[FI] S.16 Planning Application No. A/NE-TK/832 - Further Information

**1<sup>st</sup> Further Information**

**Proposed Temporary Holiday Camp, Place of Recreation, Sports or Culture  
(Barbecue Site and Hobby Farm) and Eating Place with Ancillary Facilities for a Period of 3 Years  
and Associated Filling of Land in "Agriculture" and "Open Space" Zones and Area shown as 'Road',  
Various Lots in D.D. 17 and Adjoining Government Land, Ting Kok, Tai Po, New Territories**

**(S.16 Planning Application No. A/NE-TK/832)**

Run-in/out and Pedestrian Crossing Proposal  
accepted under previous application No. A/NE-TK/678

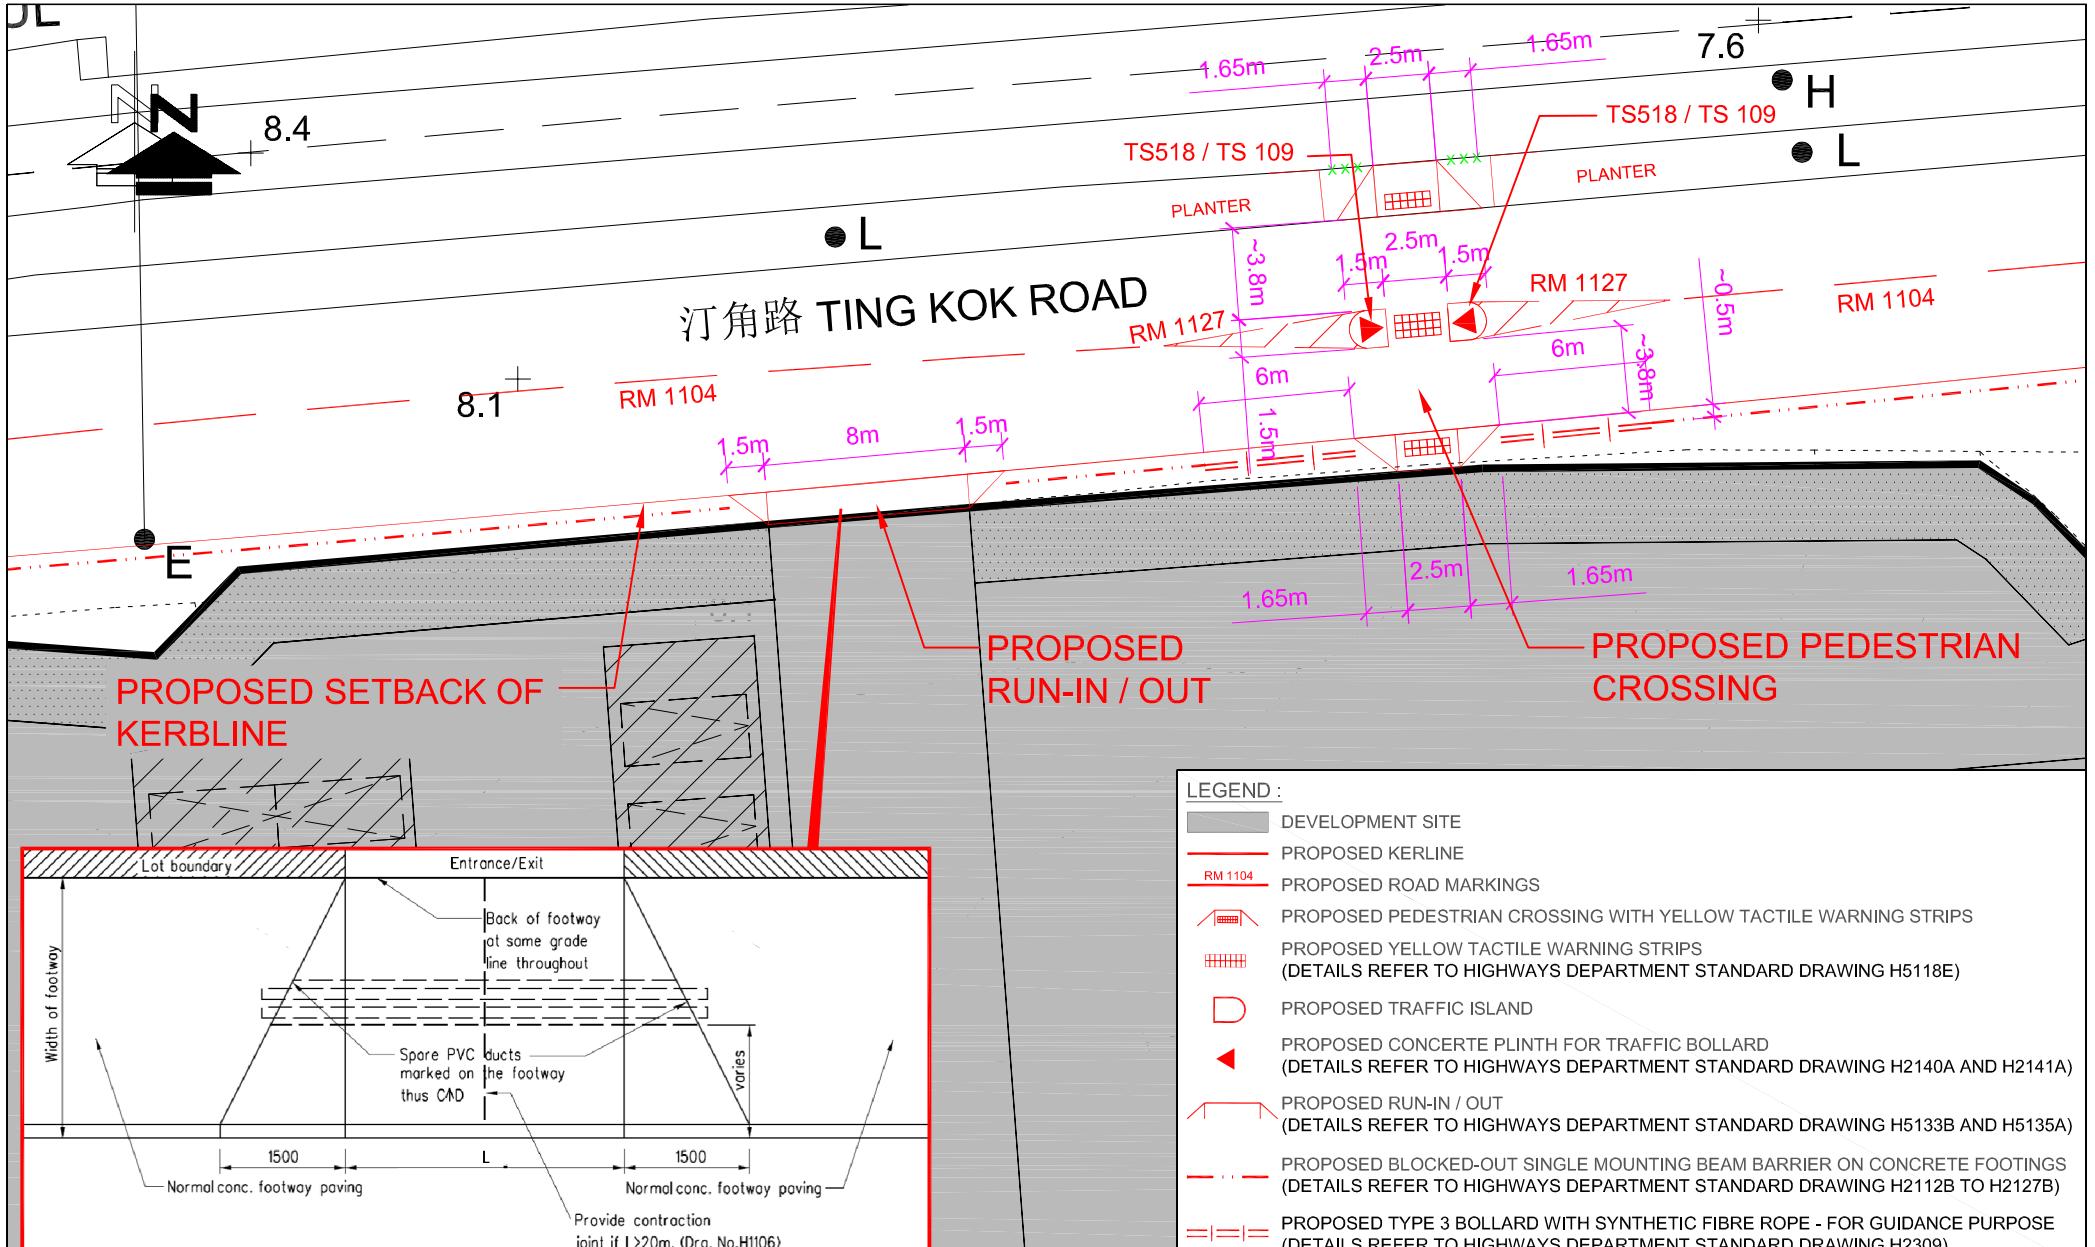
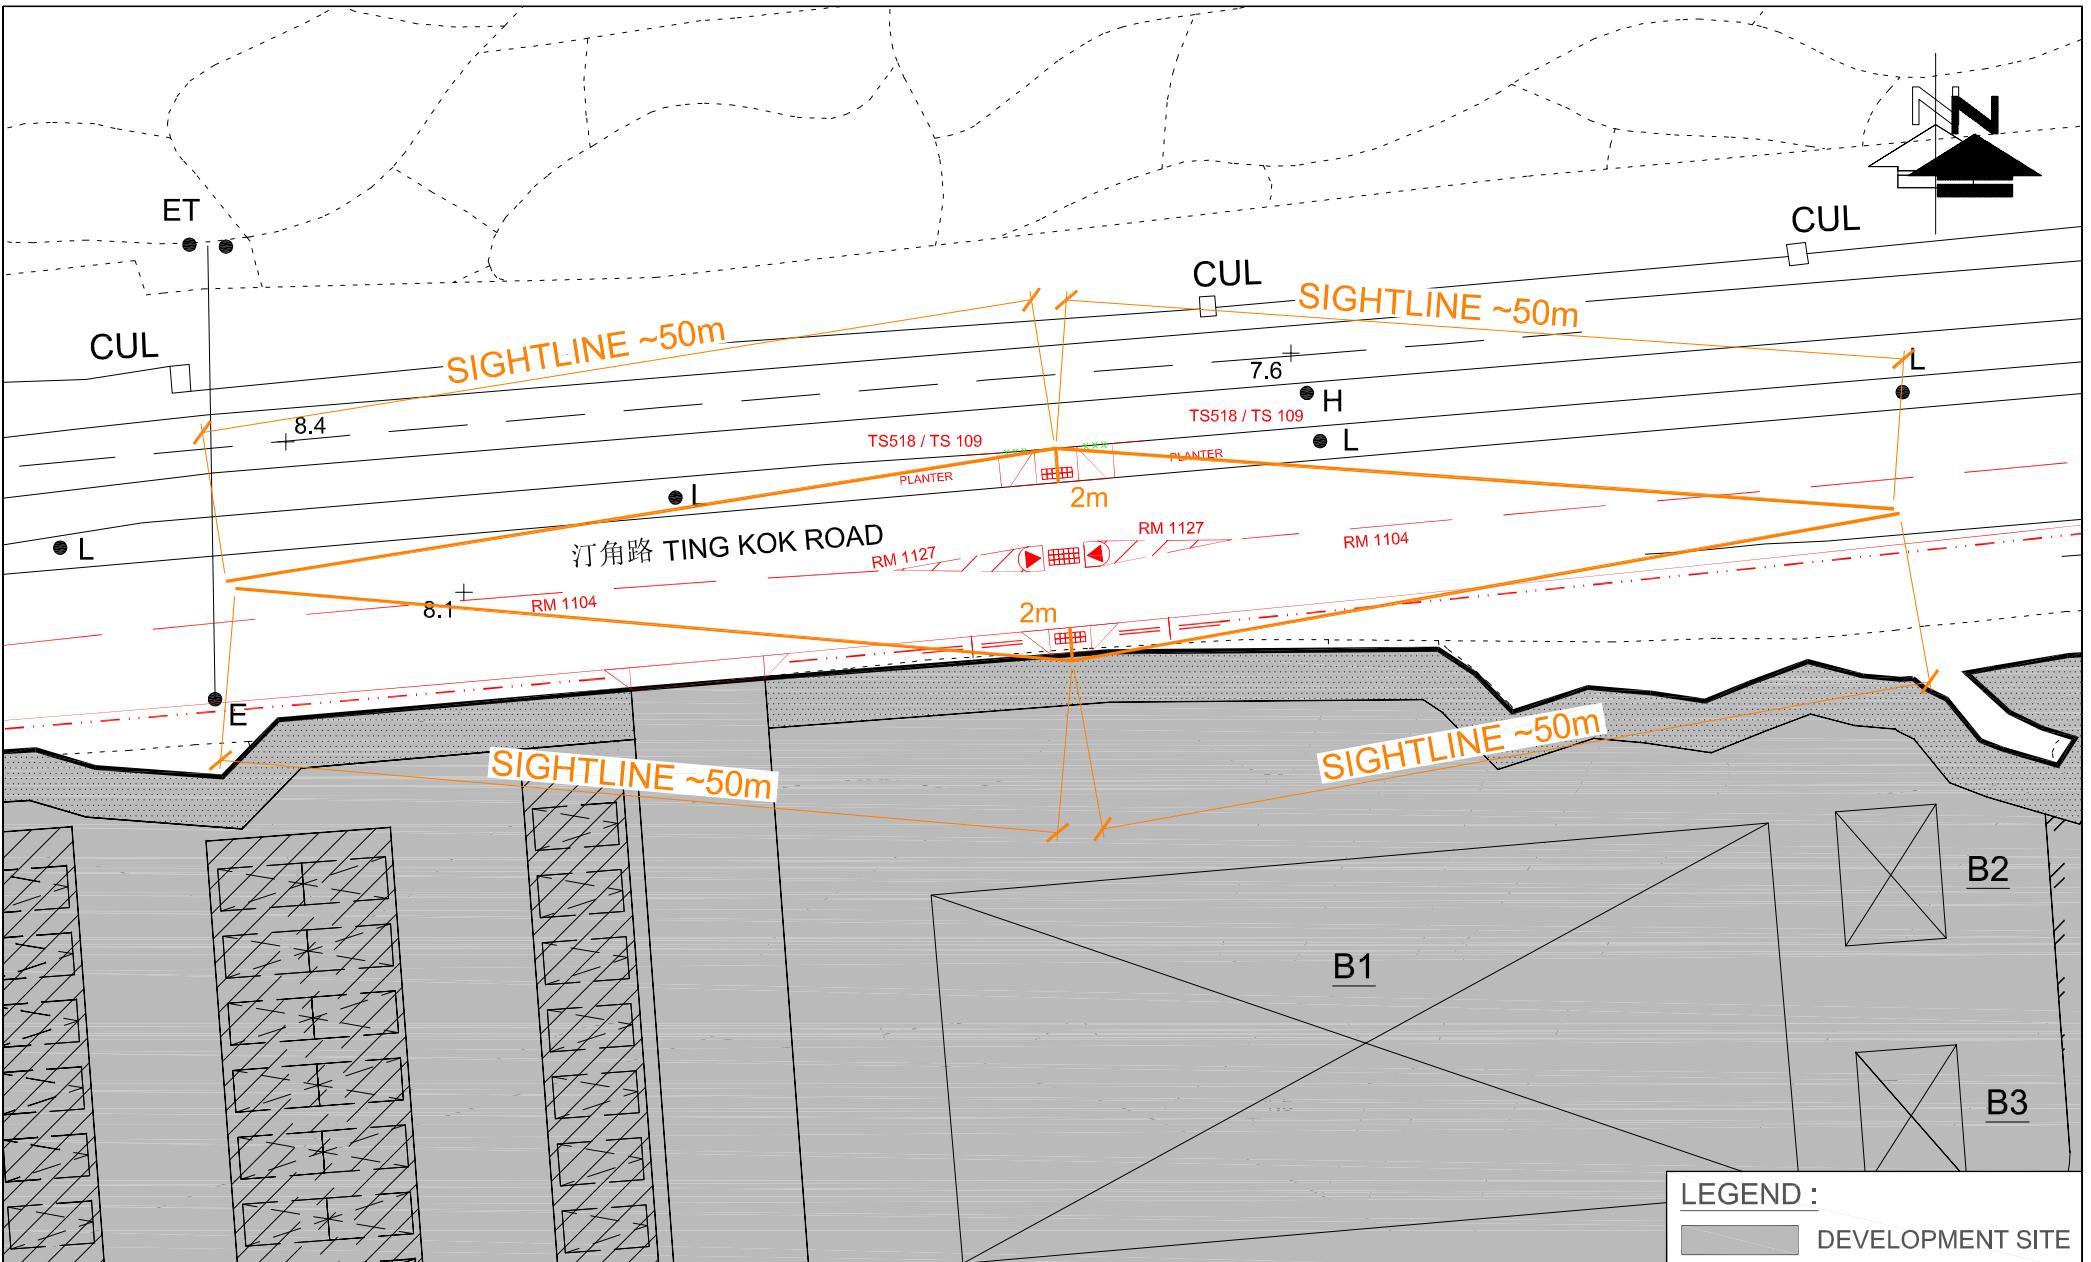
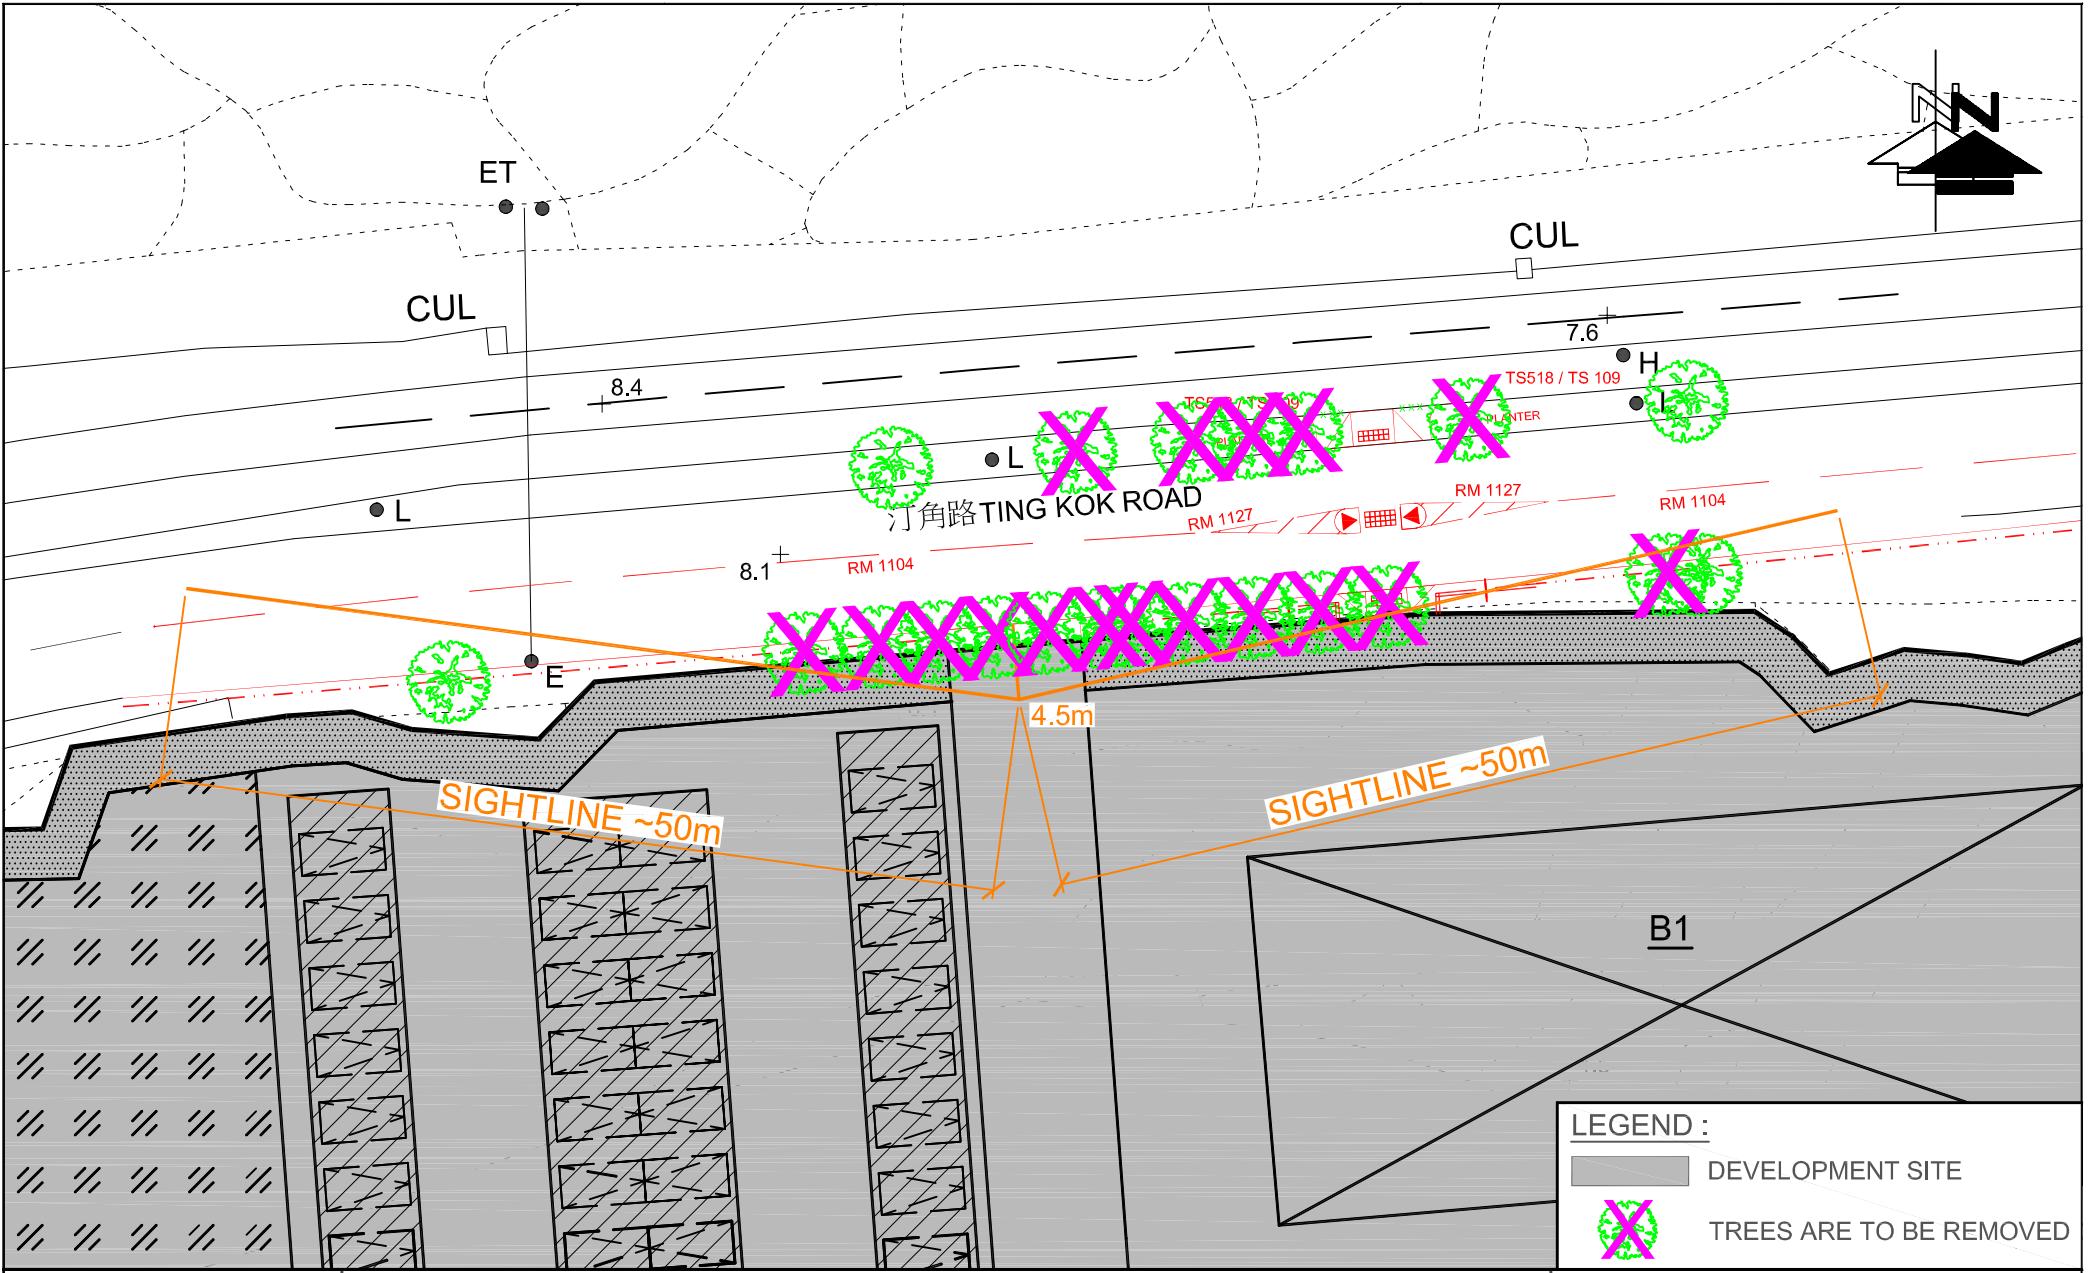
(e)	The applicant shall implement the run-in/out proposal and pedestrian proposal submitted under previous planning application No. A/NE-TK/678 as mentioned in the Planning Statement.	Noted. The applicant shall implement the run-in/out proposal and pedestrian crossing proposal submitted under previous planning application No. A/NE-TK/678 at <b>Annex 1c</b> .
